R66 SERVICE BULLETIN SB-12

SUBJECT: Landing Gear Attach Nuts

ROTORCRAFT AFFECTED: R66 helicopters S/N 0002 thru 0547.

FIGURE 1

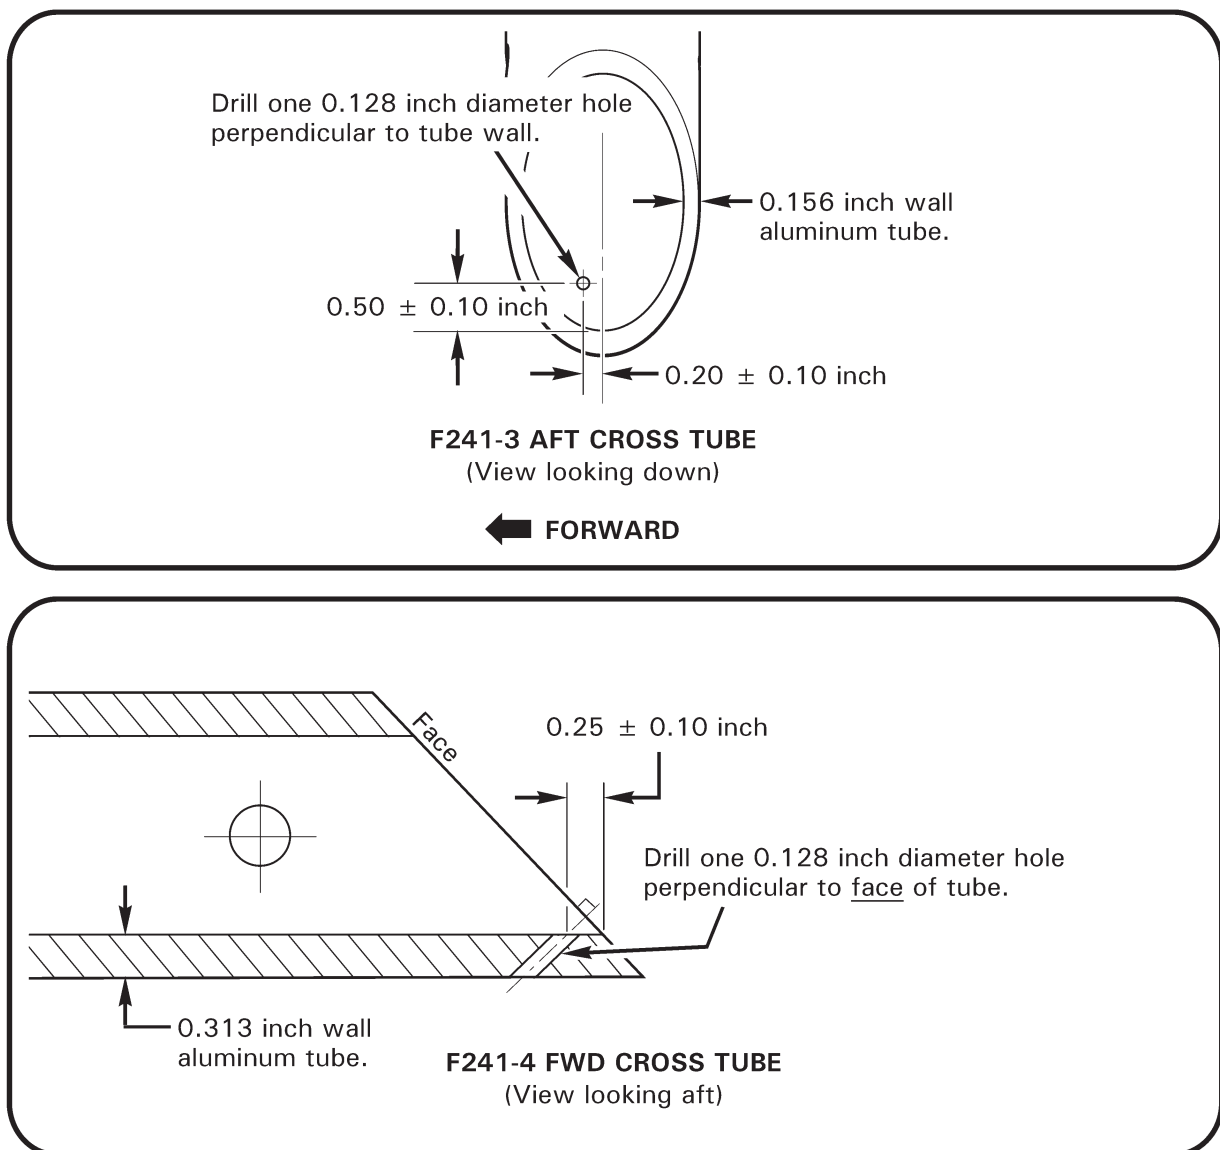
5. Refer to Figure 1. Lay out vent hole location on left side of F241-3 (aft) cross tube and left side of F241-4 (forward) cross tube as shown. Drill one 0.128 inch diameter hole in each cross tube and deburr. Clean up debris.
